Brisbane CBD Bicycle User Group

I write to you on behalf of CBD BUG members regarding the proposed Brisbane Metro project and its ability if correctly planned for all users to transform Melbourne Street (between Grey & Merivale Street) into a modern multi-modal transport corridor.

Figure 2

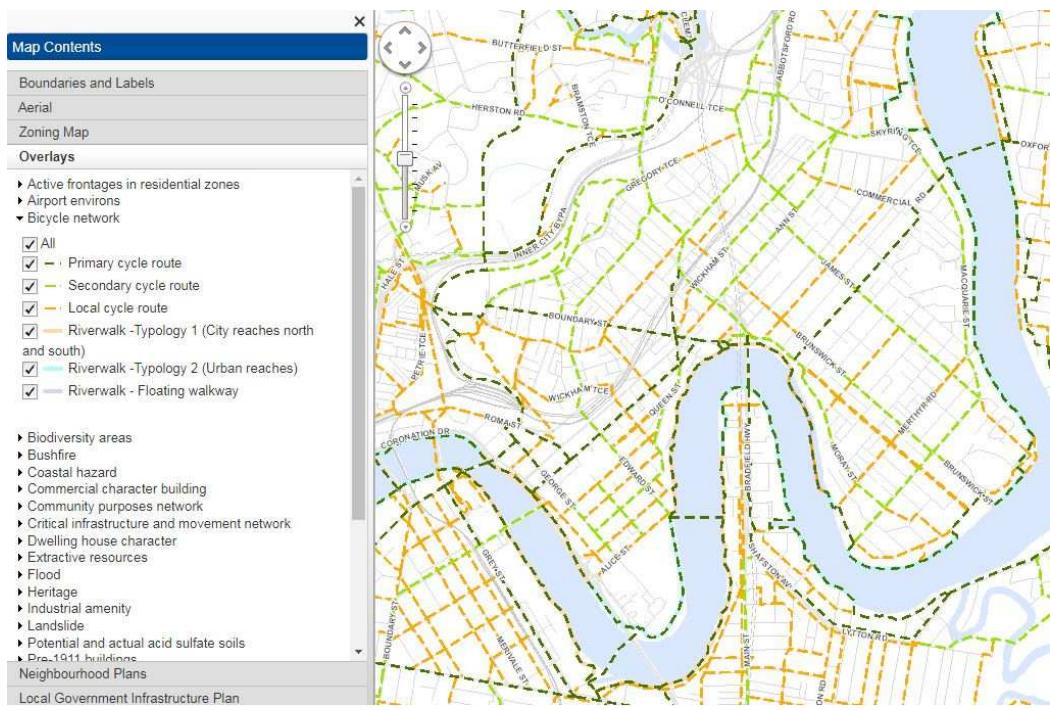
Instead, the CBD BUG proposes that the arrangement be reconfigured so that all travel modes are separated and safe. Importantly, our measurements of the road space have ascertained there is sufficient room to accommodate bicycle riders safely as per our alternative plan. (Figure 2)
